**RECORD OF DECISION FOR THE  
LANDFILL OPERABLE UNIT OF THE  
TONAWANDA LANDFILL VICINITY PROPERTY  
TONAWANDA, NEW YORK**

**AUTHORIZED PROJECT UNDER THE  
FORMERLY UTILIZED SITES REMEDIAL ACTION PROGRAM**

**September 2017**

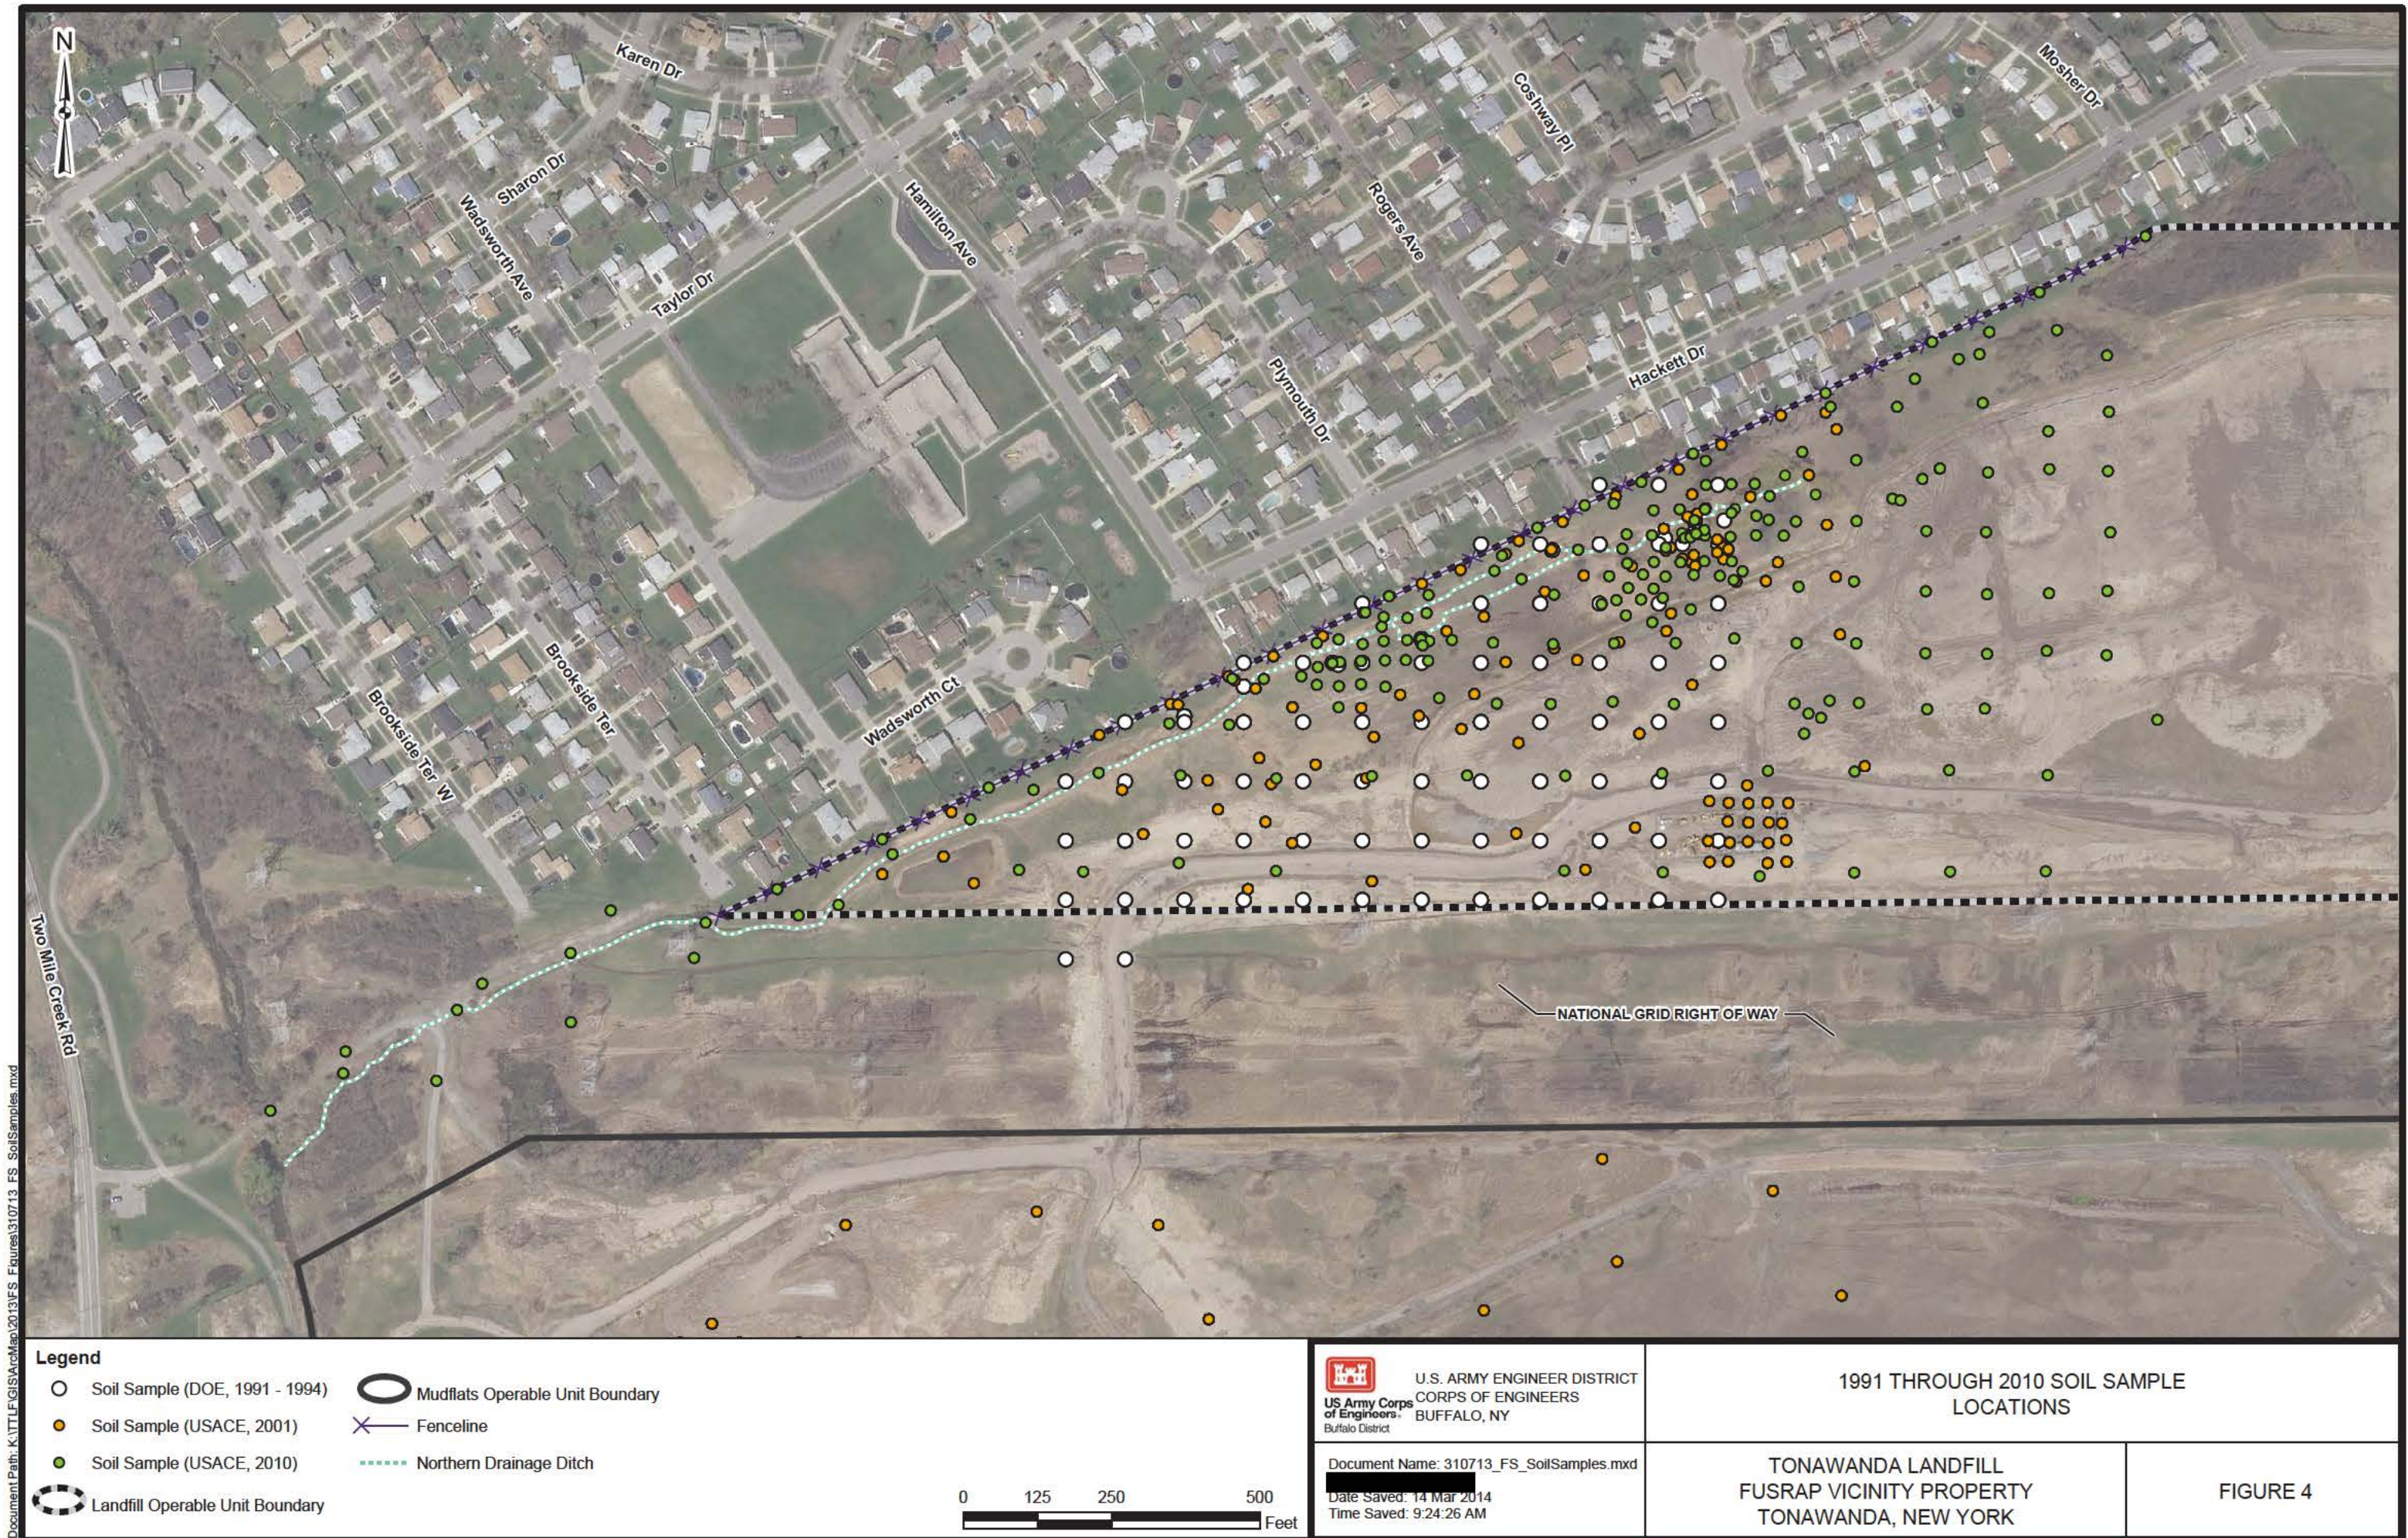
Appendix A Comment 29: The current Phase I capped area is larger than the area shown in Figure 3. The current Phase I cap extends south to the site haul road, and covers 27.8 acres as opposed to the 25 acre cap shown in the Corps figures and discussed in the text. Does this influence any of the model predictions, with respect to timing of plume movement?

## ***Figure 1***

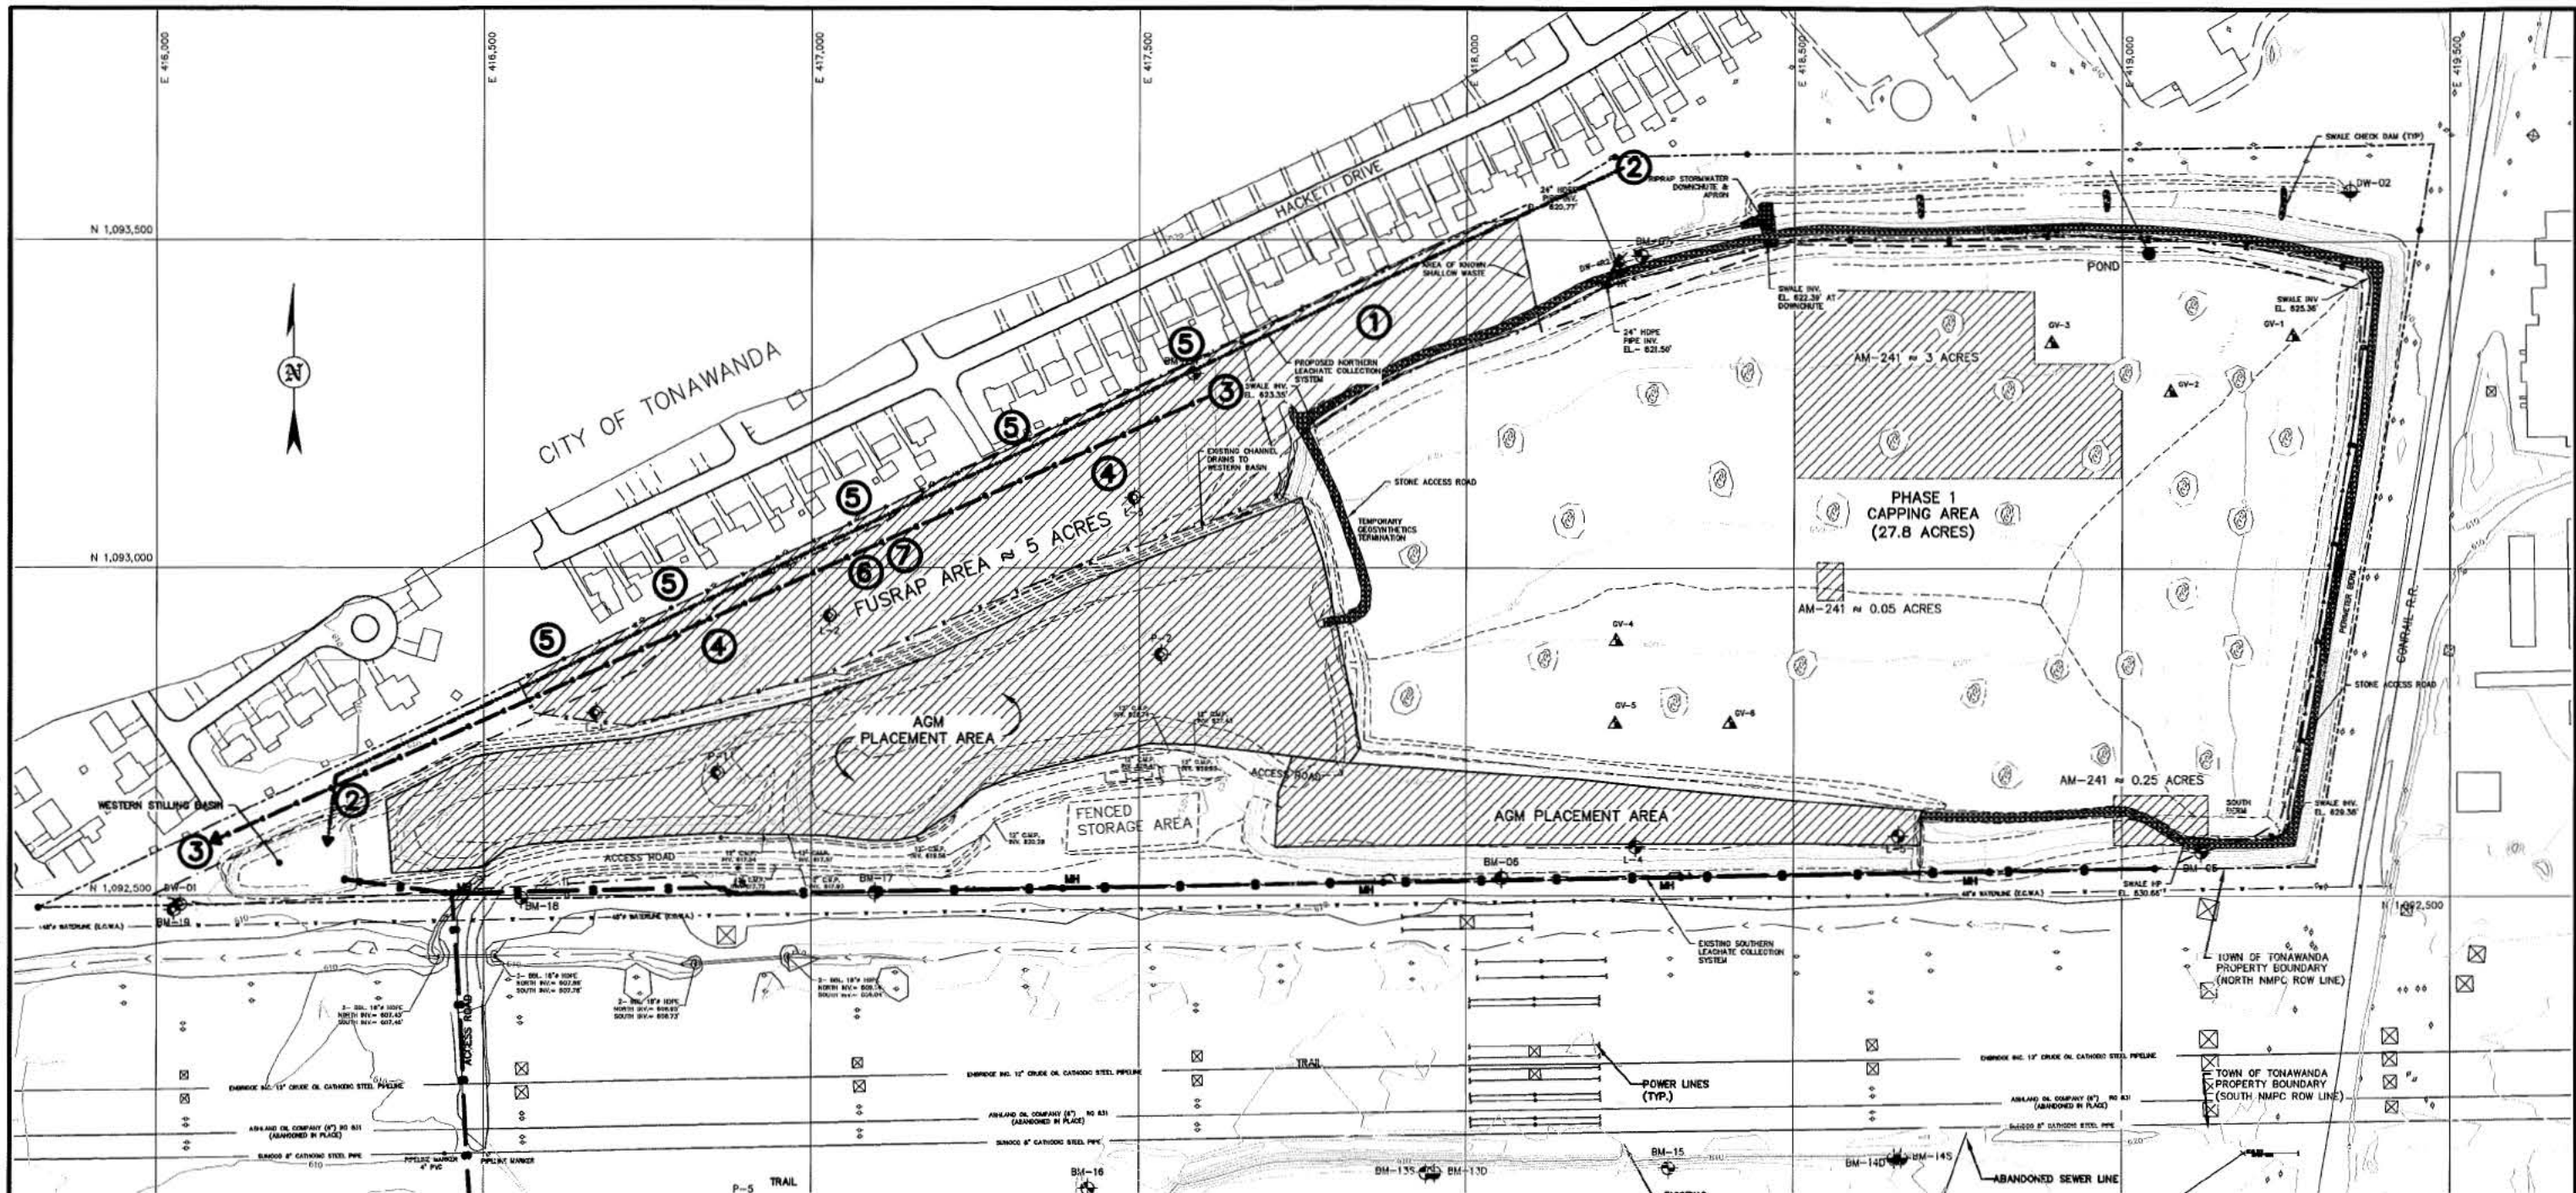
The following comments are in direct response to the Proposed Plan which documents the selection of Alternative 3: Targeted Shallow Removal and Off-site Disposal of FUSRAP-related Material as the preferred remedial method to address radiological contamination present in the FUSRAP area. Refer to Figure 1, attached, for a depiction of the following numbered comments.

FIGURE 6-1

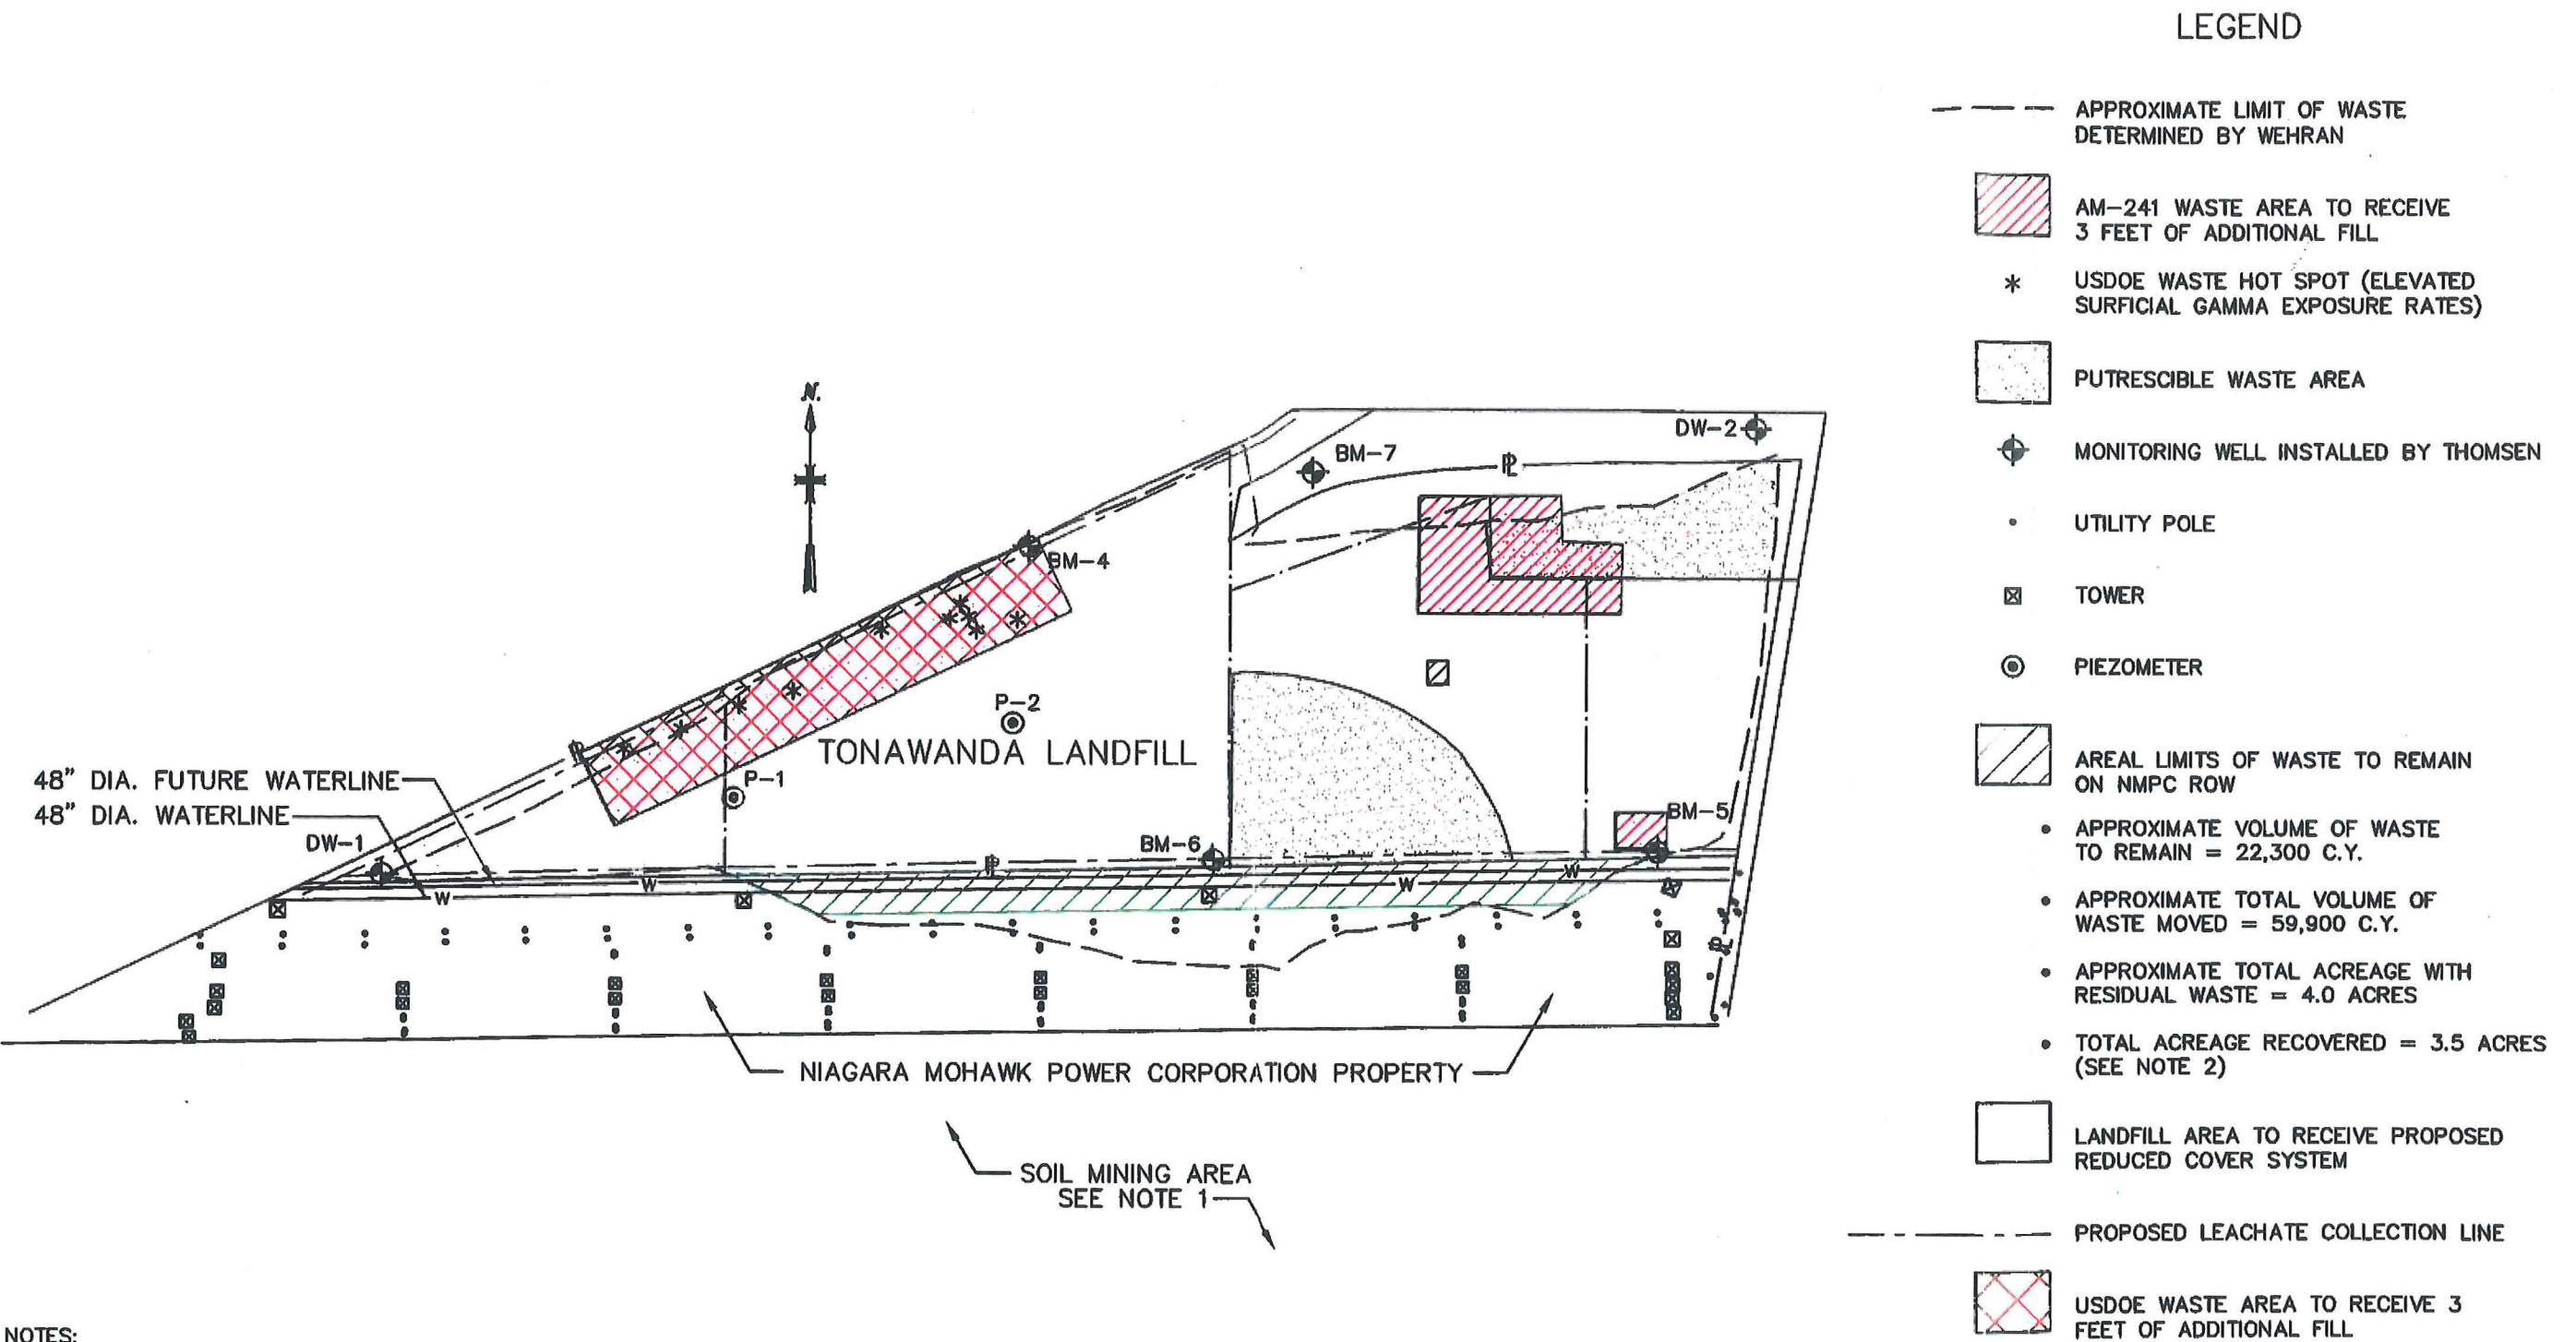
- In areas that received Americium-241 contaminated ash, provide an additional three feet of clean fill material. The approximate limits of the Americium-241 areas are shown on Figure 6-1.

- In areas where uranium by-products were disposed, provide a minimum of three feet of cover material. The approximate location of the areas which received uranium by-products are shown on Figure 6-1.
